Re: 09-AFC-7 Palen Solar Power Project

**Re: Comments on the Preliminary Determination of Compliance for
the Solar Millennium Palen Solar Power Project (No. 163054)**

*Re: Review of Preliminary Determination of Compliance for Palen Solar Electric Power Project
(Application No. 502597)*

Figure 1: Therminol VP-1 Temperature vs. Vapor Pressure
(data from Solutia Technical Bulletin 7239115B, 1999)

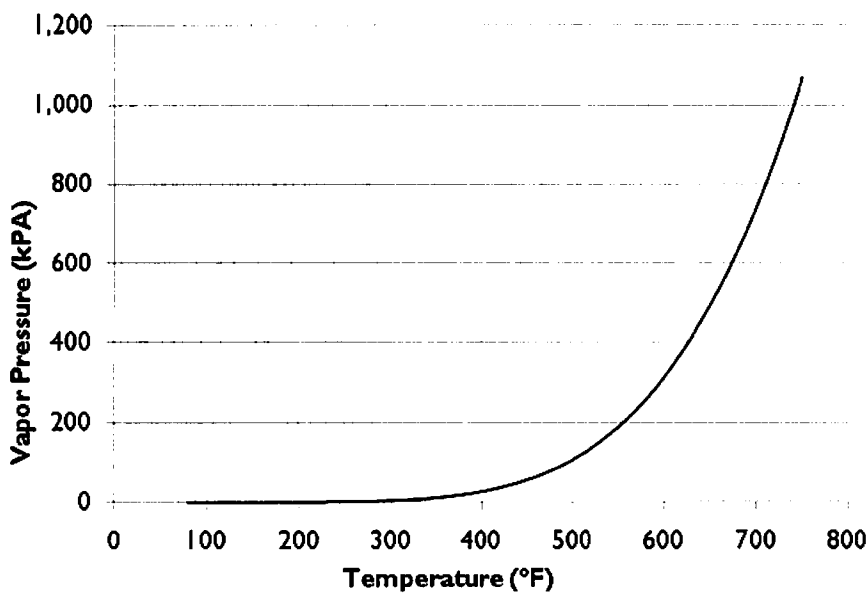
However, the HTF daily operating range cycles between approximately 430°F and 740°F every day;⁷ during normal operation, HTF enters the solar field at 565°F and leaves the field at 739°F.⁸ Thus, for most of the day and during normal operation, the operating temperature is above the normal boiling point of the HTF of 495°F.⁹ The vapor pressure at these operating temperatures rises drastically and ranges from about 40 kilopascals ("kPA") at 430°F to about 220 kPA at 565°F and 900 kPA at 740°F, as shown in Figure 1.¹⁰

Further, as the HTF is cycled within the indicated temperature range, degradation of the HTF occurs resulting primarily in phenol, and benzene with smaller concentrations of benzene, phenol, and small amounts of naphthalene, methane, ethane, and toluene.¹¹ These compounds have lower boiling points and higher vapor pressure.

Because the HTF expands with increasing temperature and is contained in the HTF system piping, the system pressure rises to a maximum of about 40 bars while the fluid is pumped through the solar fields. Under these fluid conditions, *i.e.*, high operating temperatures and high system pressure, any release of HTF from piping components would spontaneously occur in gaseous form.

Thus, because the HTF piping system does not operate under atmospheric conditions (68°F and 1 bar), the SOCOMI emission factors for "Heavy Liquid" are not appropriate for calculating fugitive VOC emissions from the Project's solar fields. Rather, the emission estimates should be based on emission factors for "Light Liquid" and "Gas". (Of course, it would be far preferable to conduct field measurements at existing solar trough plants, *e.g.*, the SEGS plants at Kramer Junction, CA, rather than relying on average SOCOMI emission factors conducted at industries with entirely different operating conditions.)
